Service Bulletin 14/2

Affected Aircraft: All SNo's of motorglider type H 36-Dimona

Subject: Elevator connection

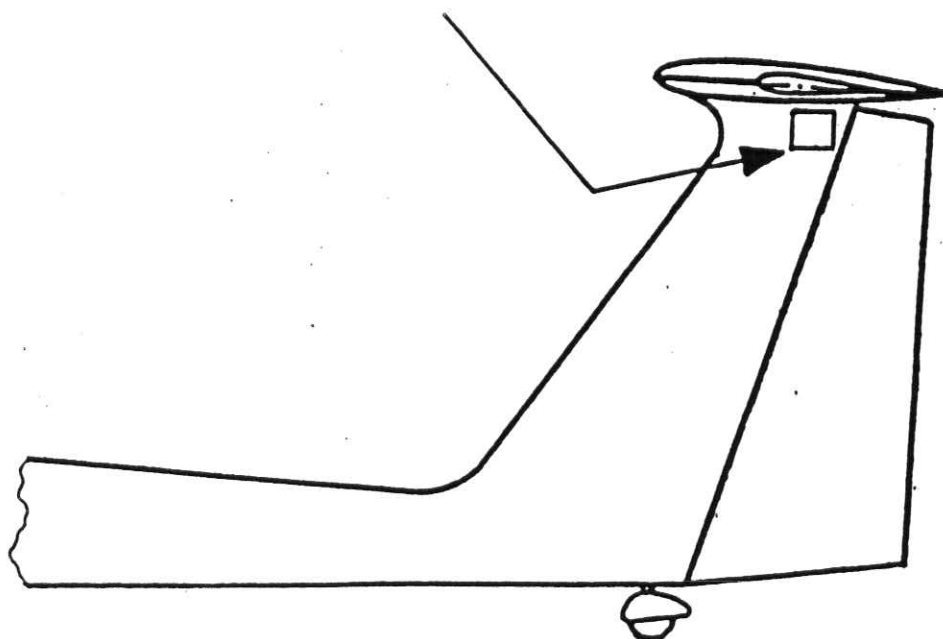
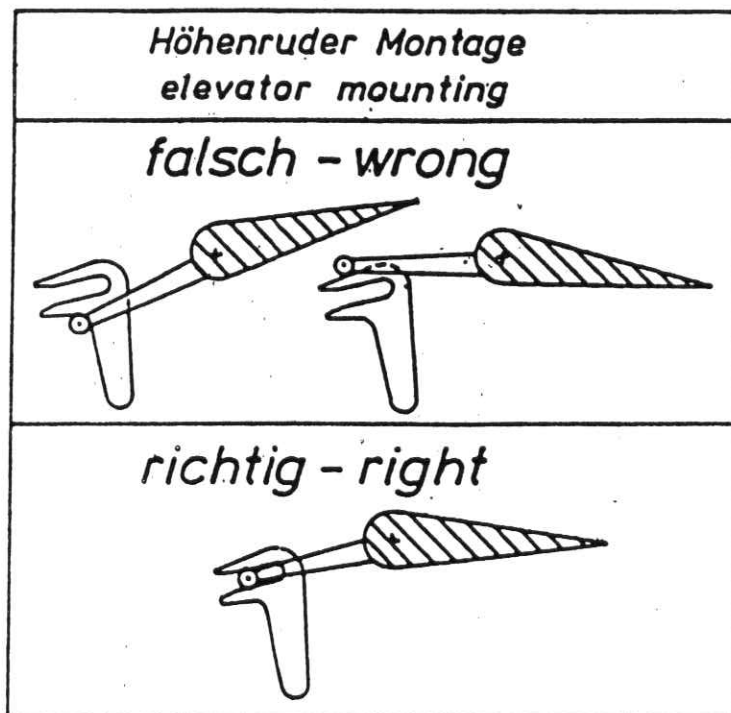
Occasion: Possibility of mounting the horizontal fin without connecting the elevator.

Action: 1.) Execution of the actions described in service bulletin 14  
2.) Fix a self adhesive badge, which shows the right connection of the elevator (sketch page 2)  
3.) Insert page 17 (section 2) into flight manual
